ADDENDUM NO. 2

IRONDALE FIRE STATION No. 3

Project Name: Irondale Fire Station no. 3 **Project No:** CWA Project No. 2023-01

SHEET TITLE:
INTERIOR ELEVATIONS PROJECT NUMBER: CWA No. 2023-01 08/30/24 DRAWN BY: CHECKED BY: Checker

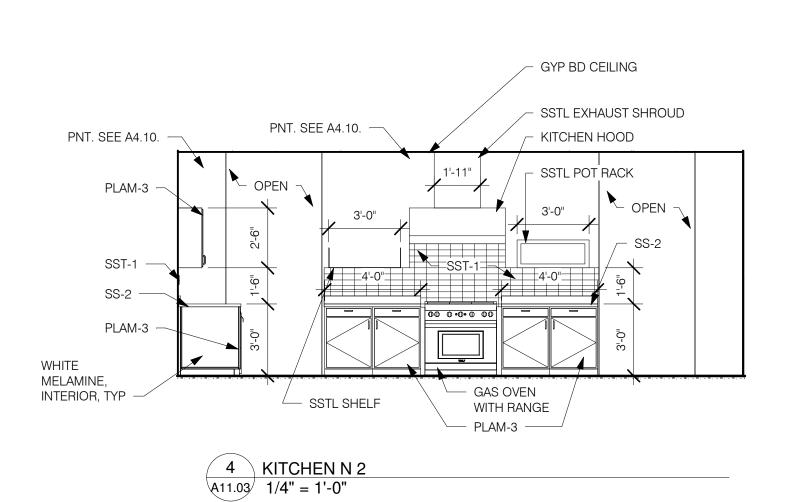
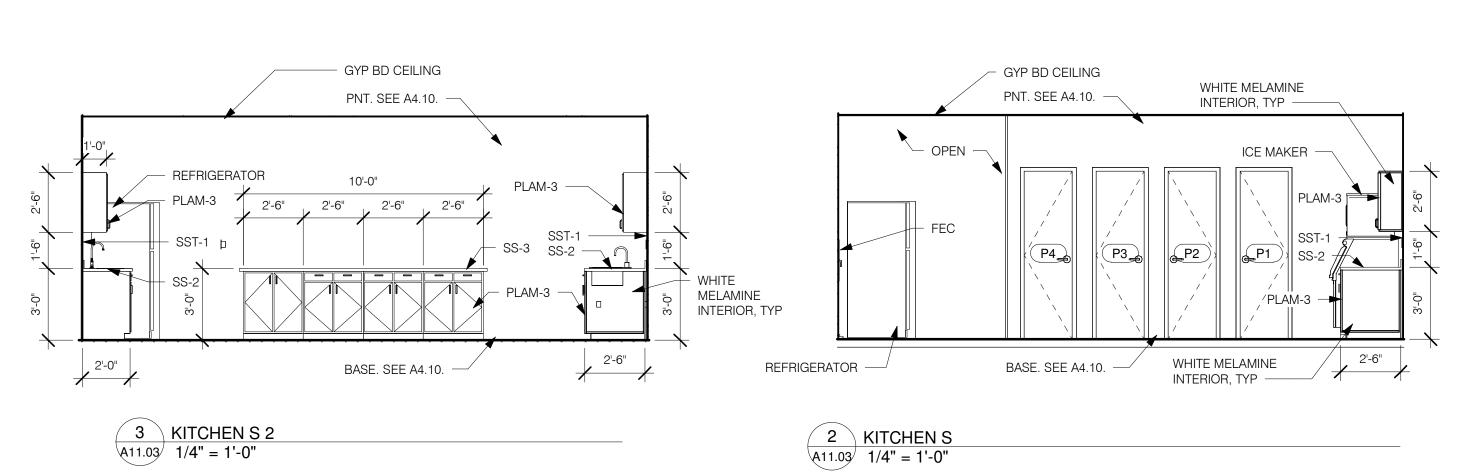
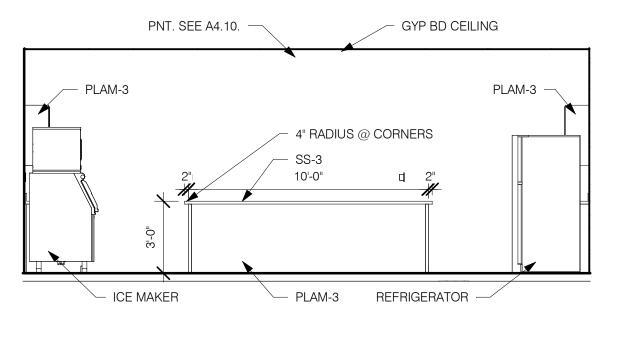
- 8. A4.10 Finish Schedule and Legend: Added finishes SST-1 and PLAM-3
- 9. <u>A11.03 Interior Elevations</u>: Added Kitchen elevations
- 10. <u>S4.6 Sections and Details</u>: lowered the column base plates 0'-6" at Front Entry.

SITE PLAN - ELECTRICAL

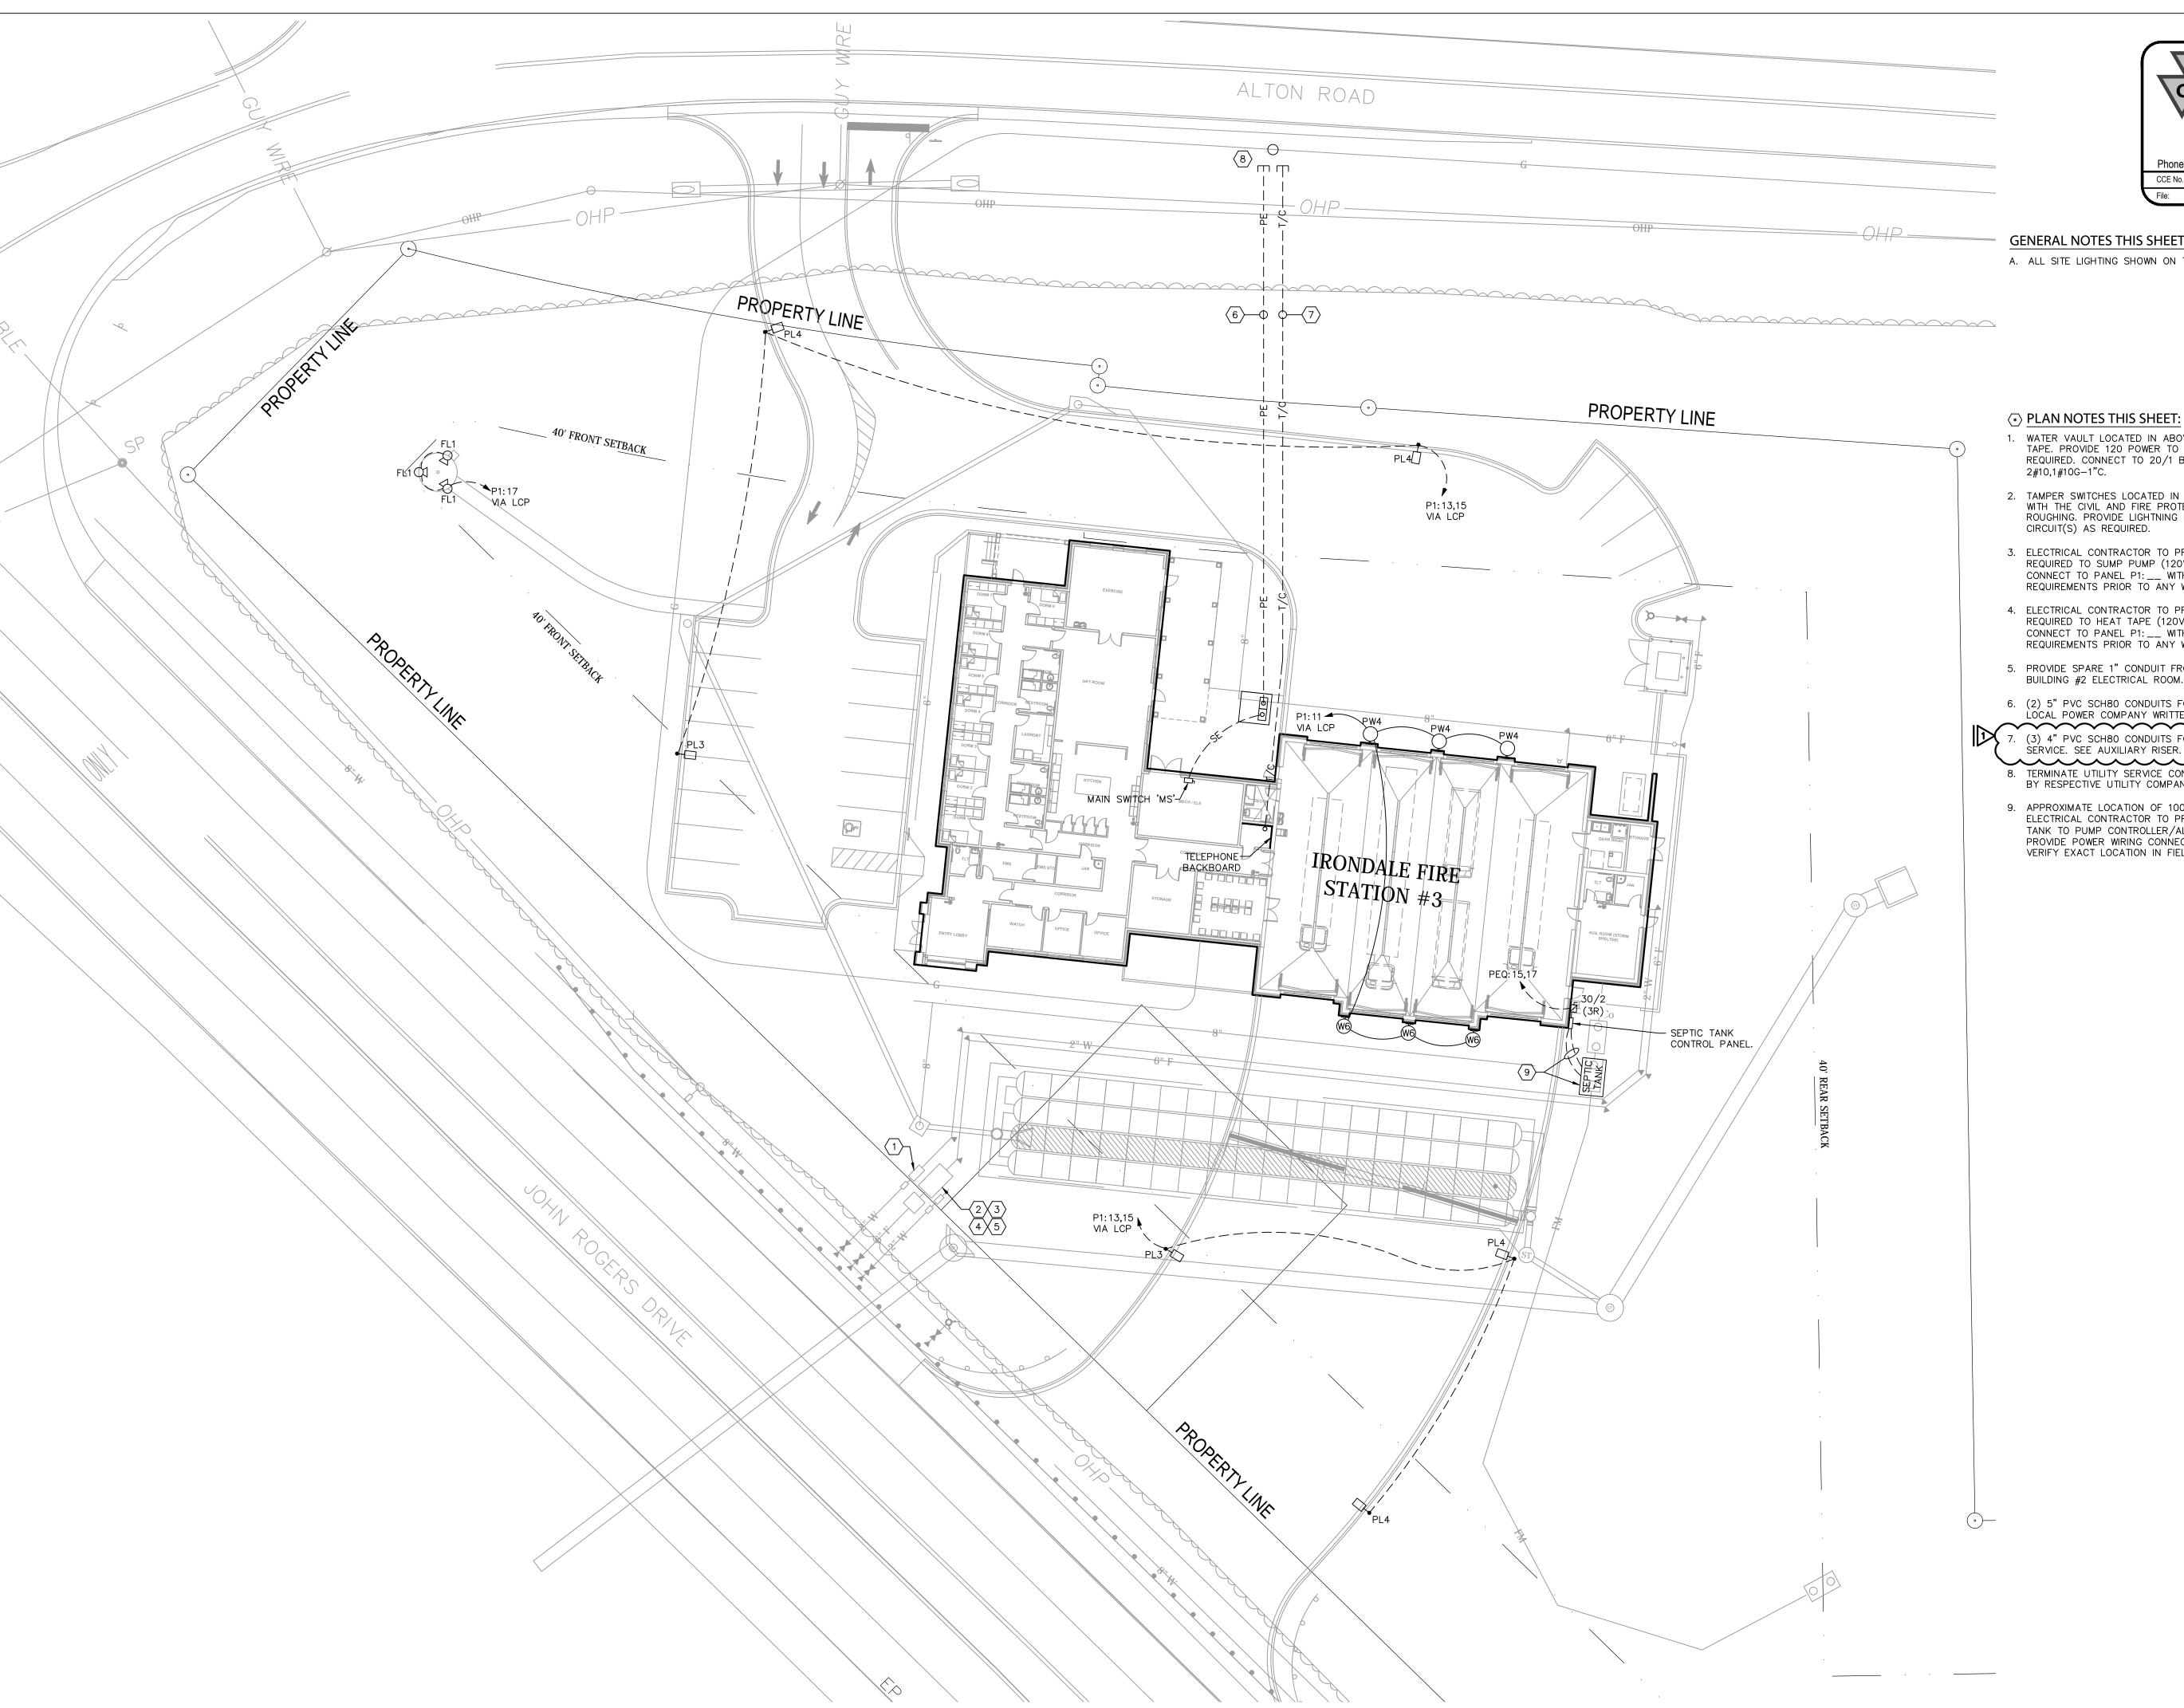
- 14. E101 Site Plan: Updated Plan Note #7.
- 15. <u>E201 Level 1 Plan Lighting</u>: Added battery inverter and applicable notes at main entry door to lobby
